**OFFICIAL COORDINATION REQUEST FOR
NON-ROUTINE OPERATIONS AND MAINTENANCE**

PROJECT- John Day Dam

John Day – North Fish Ladder Entrance Improvements: Proposed Closure of South Entrance

FFDRWG
1 March 2011
Sean Tackley (503-808-4751)

South Entrance
(currently closed)

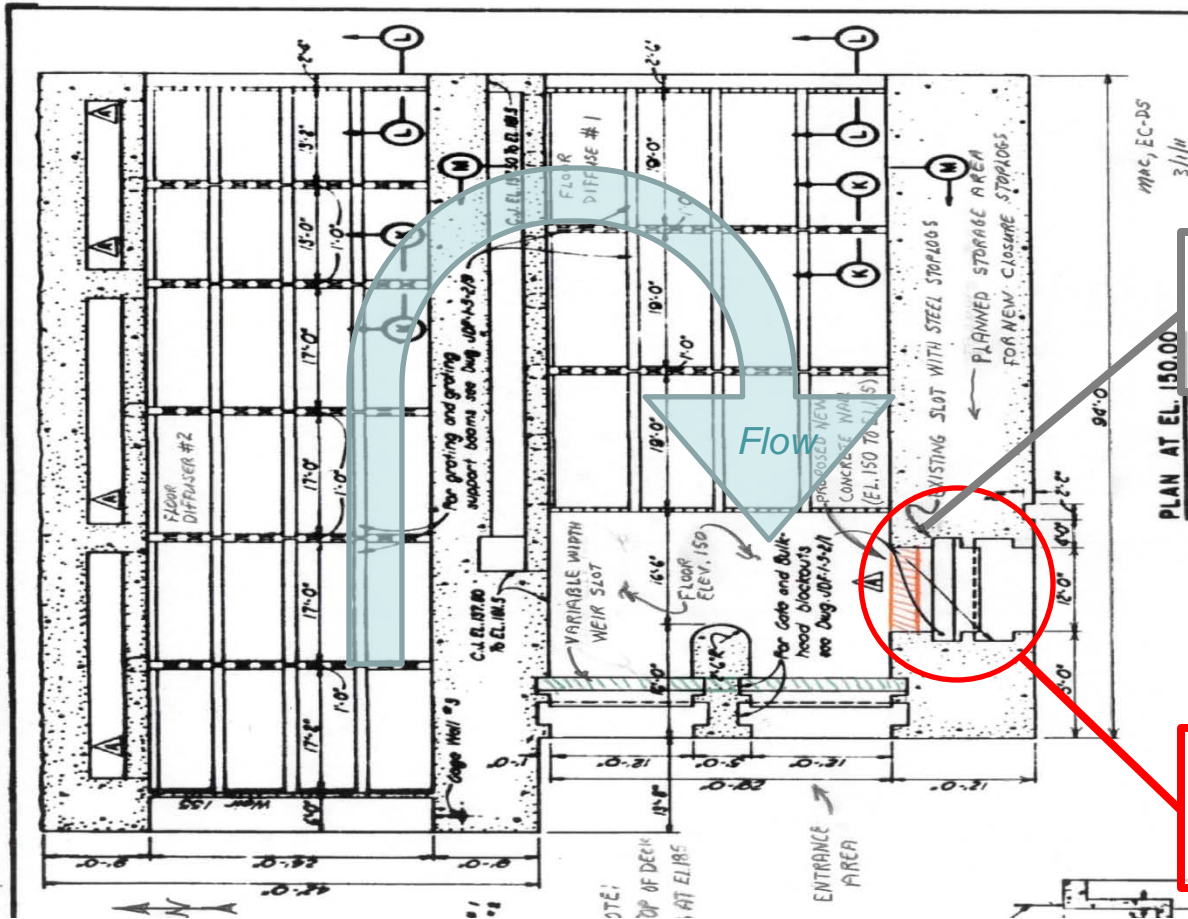
Need deck reinforcing at 185 ft. due to new crane loads. Leaves 2 options:

1. Build new stop logs *OR*
2. Install concrete wall (fishway floor to deck)

View looking up, just inside main fishway entrance.

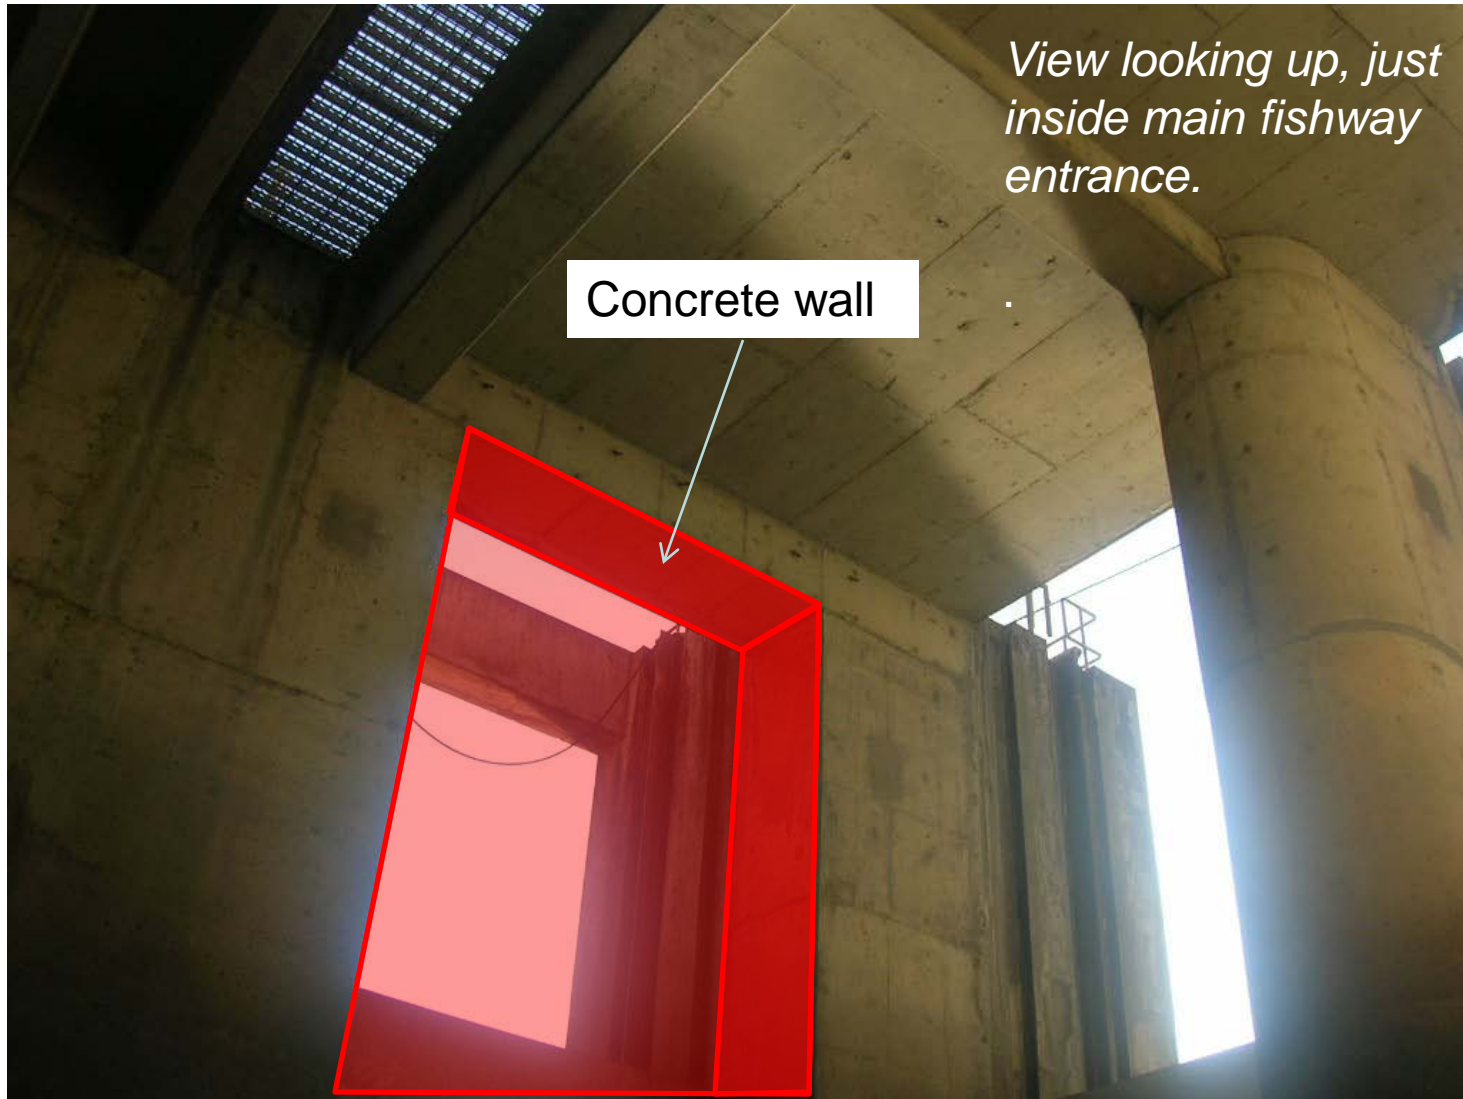
- Concrete wall on inside of fishway would be ~35 high (floor of fishway to deck)
- Eliminates need to install & maintain stop logs at this unused entrance
- Other design features?

Concrete wall

View looking down on South Entrance (main fishway entrance is in upper right corner).

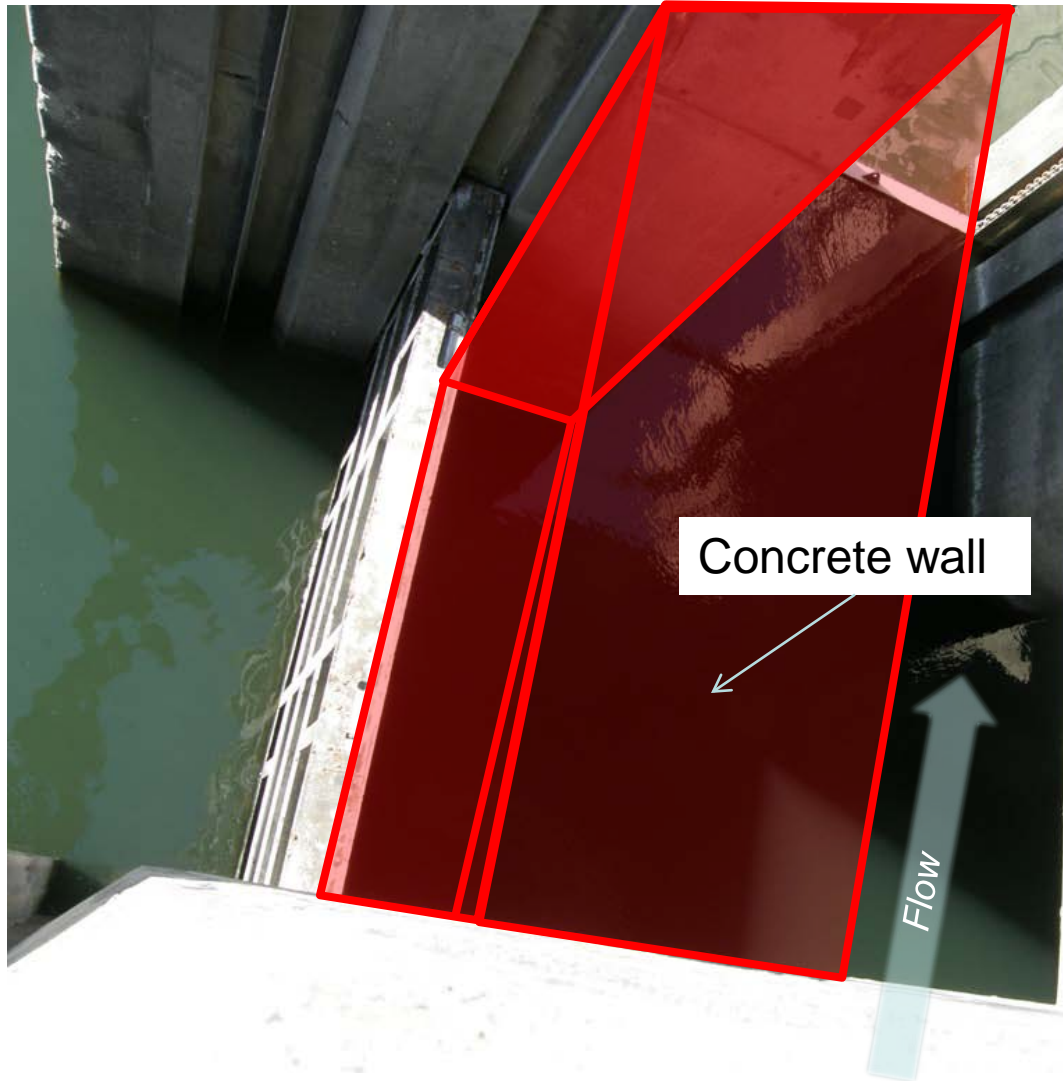
Red lines approximate the size and shape of the proposed concrete wall.
